**Re: Compark Village South Multifamily – Variance Request – Storm Drainage Criteria**

RE: **SUB21-065 // Minimum Standards Variance Request  
Hydraulic Grade Line Design Requirement**

**COMPARK VILLAGE SOUTH  
PRIVATE IMPROVEMENT  
CONSTRUCTION PLANS**

**EXHIBIT A**

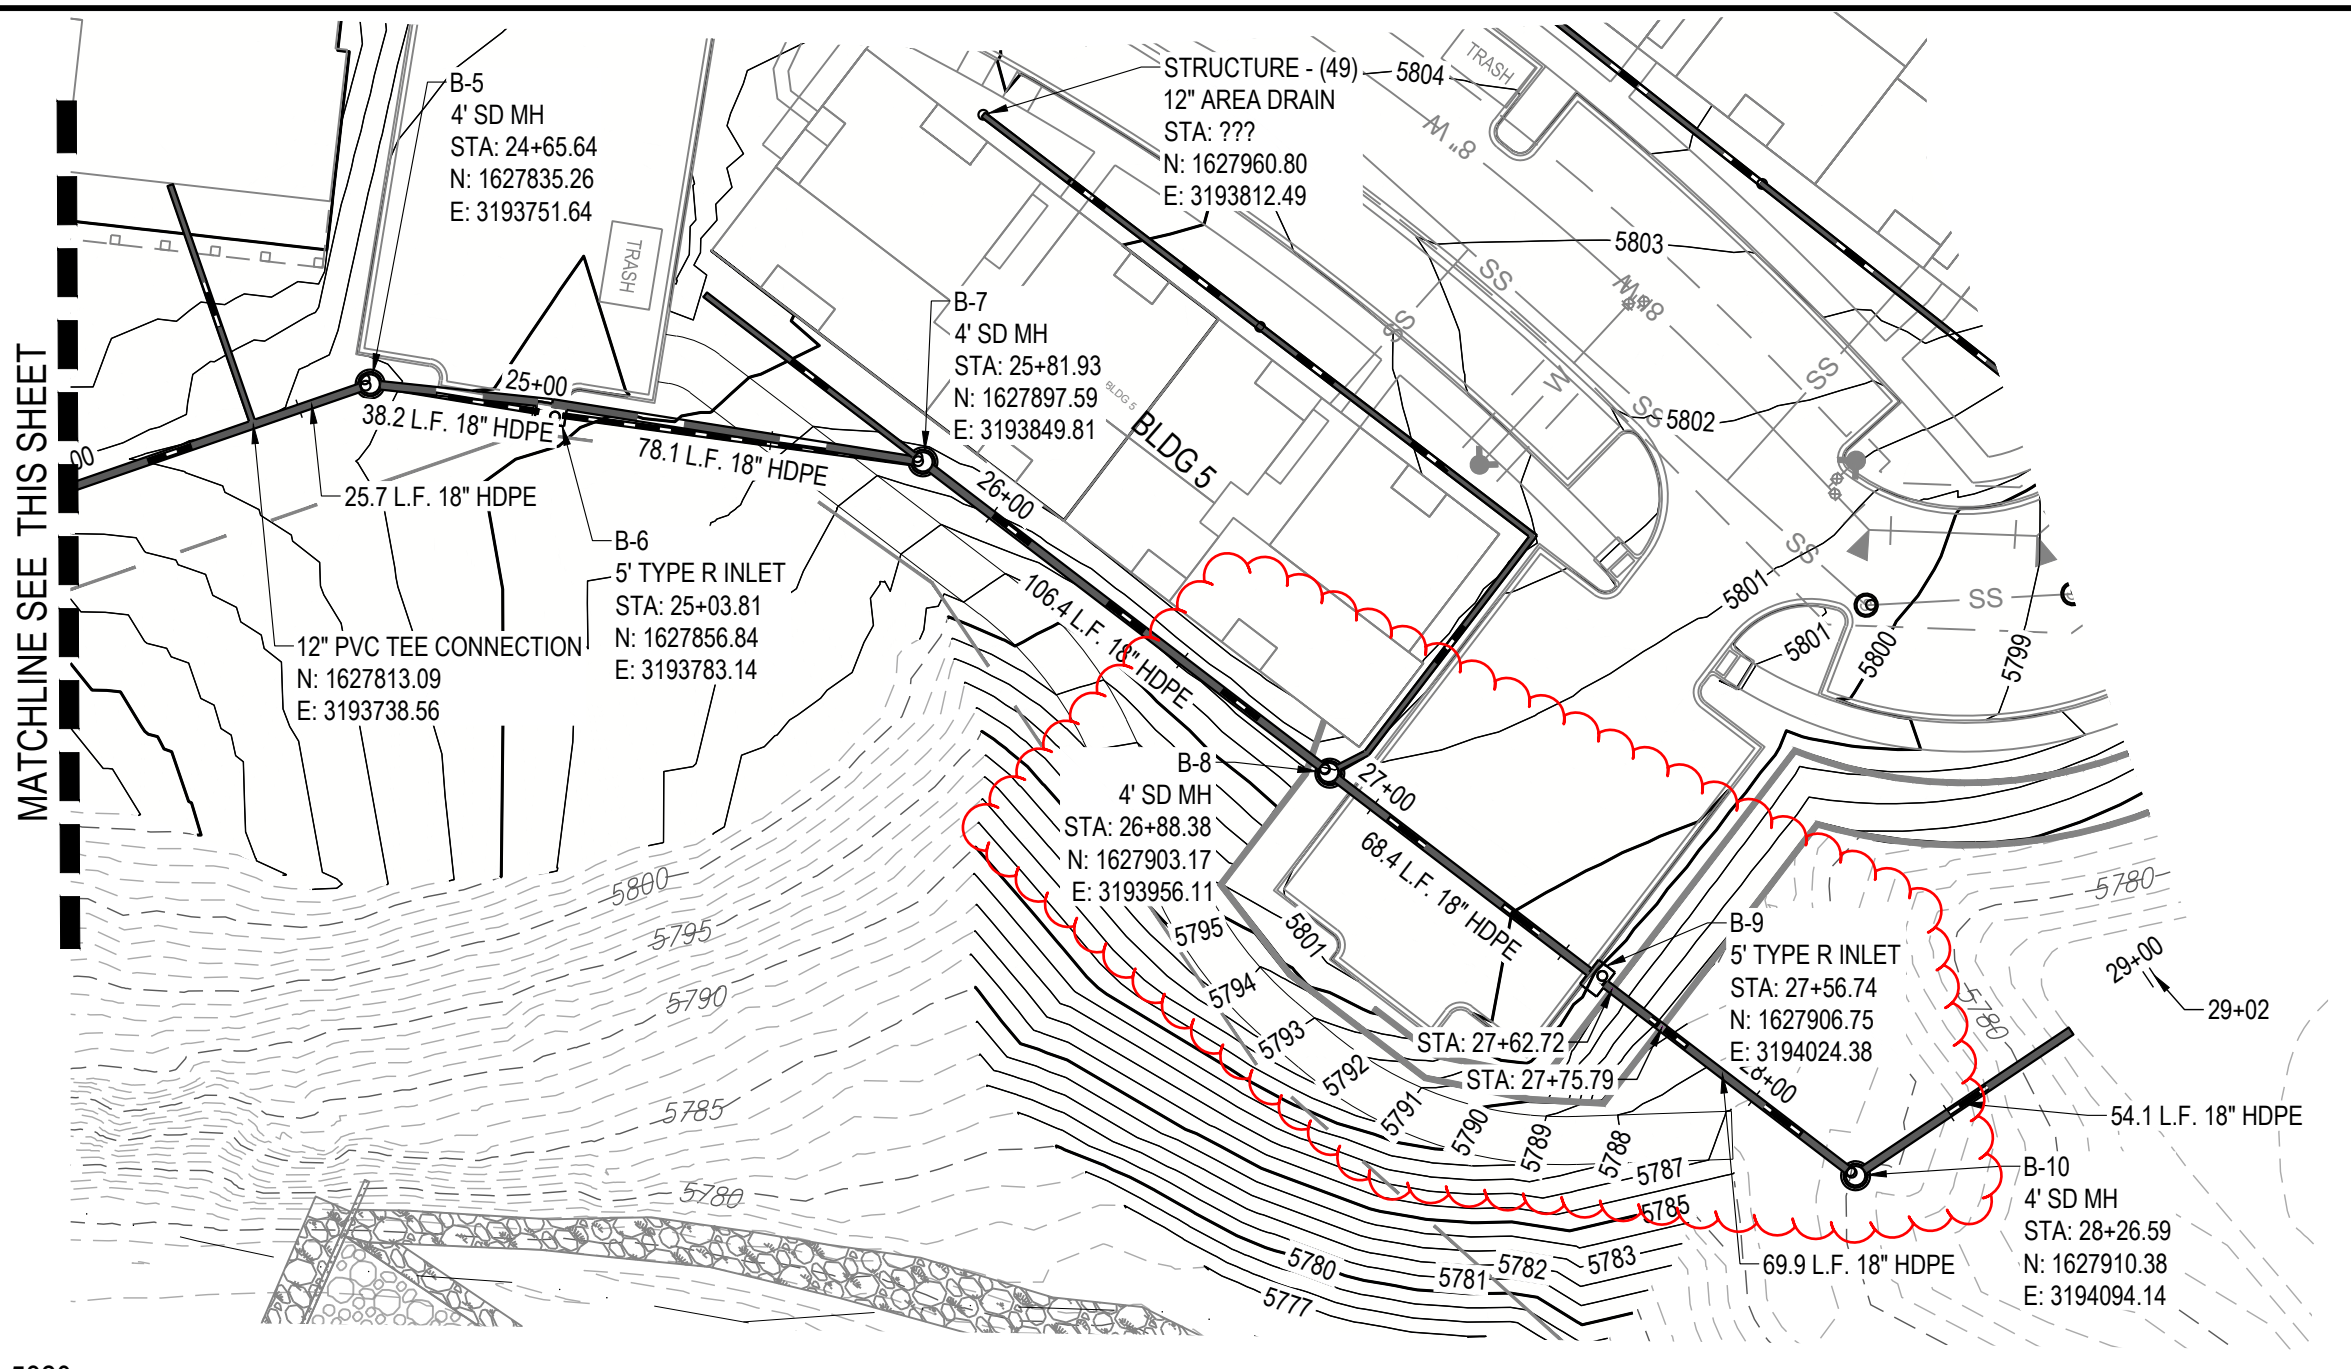
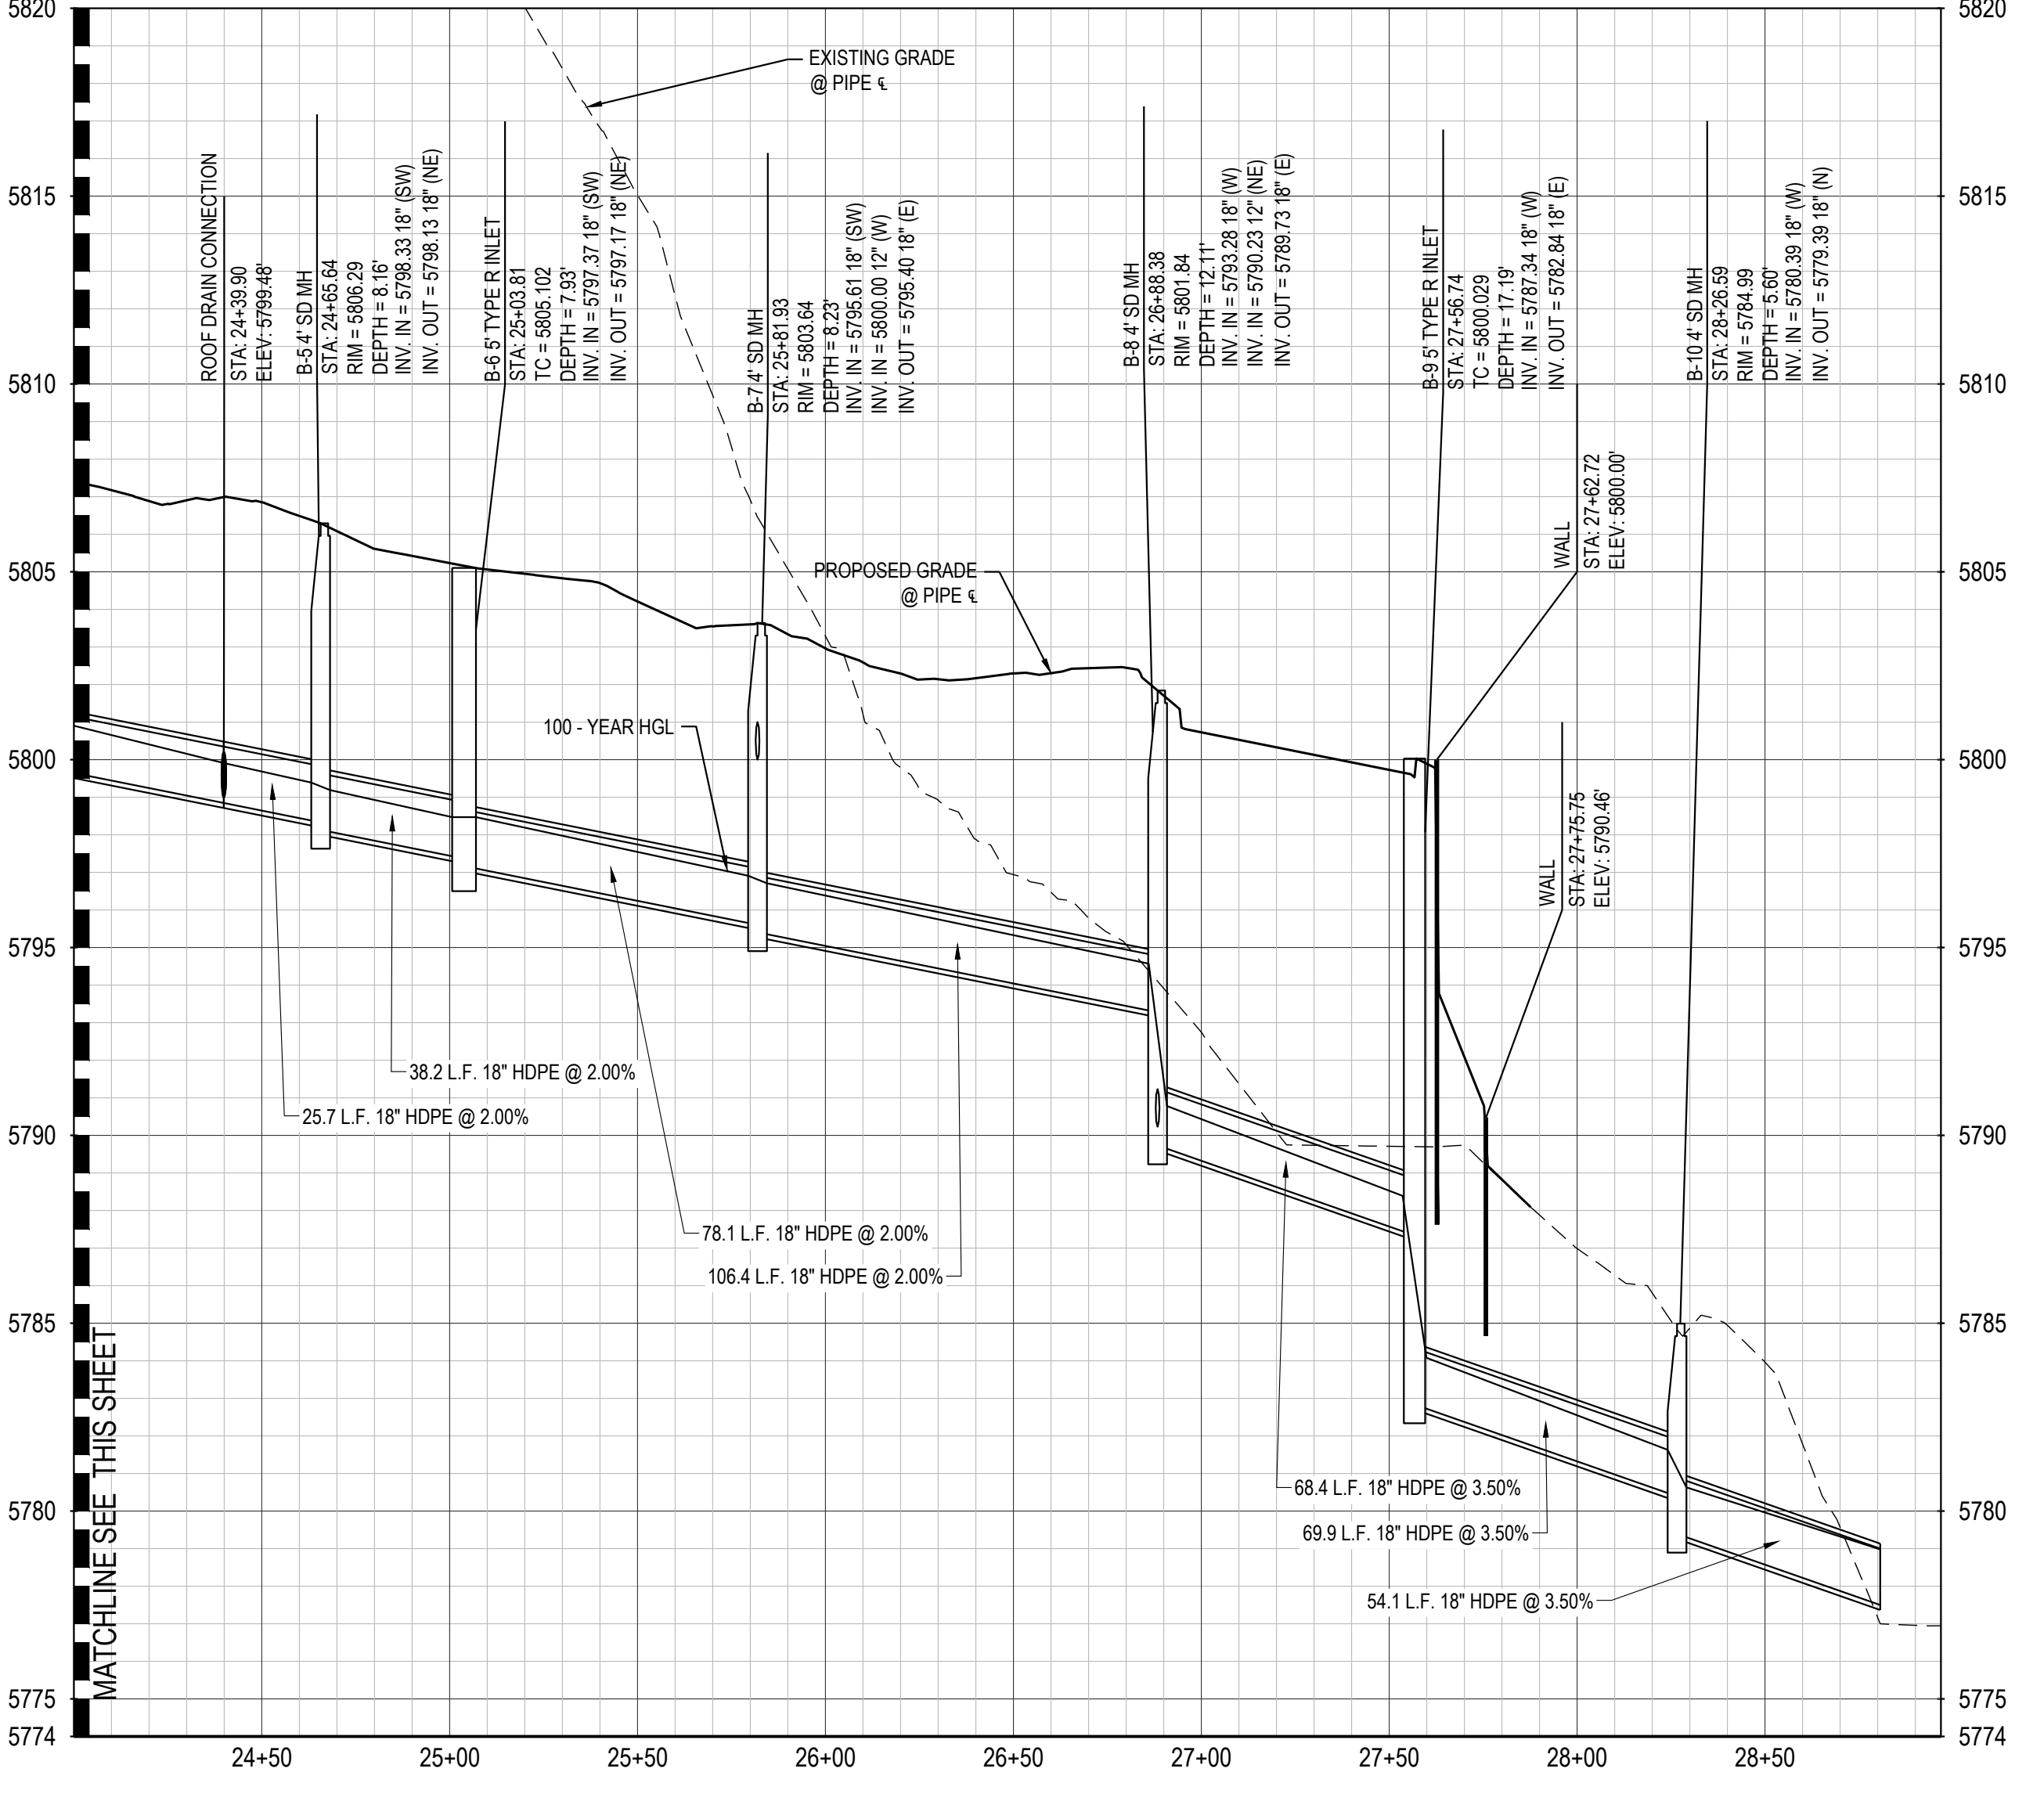
During the initial review of the Public Improvement Construction Plans for this site, the Town commented that the proposed storm sewer would need to be within a 25-ft storm sewer easement, and that proposed retaining walls (and any required structural reinforcing) could not be within that said storm easement (Refer to Exhibit A). As such, the proposed storm sewer system for the multi-family development was re-aligned such that the retaining walls would not be within the easement (Refer to Exhibit B), but in doing so, a section of the storm sewer system now fails to meet the requirements of Section 6.3.3.4 of the Towns SDECM.

1. Application SUB21-065 is still active and has not been before City Council for approval and plan check comments from Town staff are still be addressed.
2. By allowing the design as shown on Exhibit B, we believe the design as shown creates a safe and quality design. If the maintenance path were to be raised to meet the requirements of Section 6.3.3.4 of the SDECM, a retaining wall approximately 4-ft tall would be needed on the downhill side of the path, presenting a potential hazard for larger maintenance vehicles and/or trailers.

The storm sewer system was designed based on the major storm HGL having a starting tailwater elevation equal to the 100-year storm event pond water surface elevation. Should a surcharge of the system occur at manhole B-10, the plans call for a bolt down lid, and should that lid fail, it would not pose a safety risk to any structure or property given the proximity to the adjacent Flood Hazard Area Delineation.

The storm sewer structure and pipe which do not meet the Town’s criteria for HGL in the major storm should not present in any undue safety concerns. Should the storm system fail in a major storm event, no structures or public facilities would be threatened by flows, which would be conveyed to Happy Canyon Creek. Additionally, raising the elevation of the pond access road in order to meet the HGL criteria would result in a steep drop-off requiring retaining walls, which would create an undesirable condition for maintenance vehicles using this access.
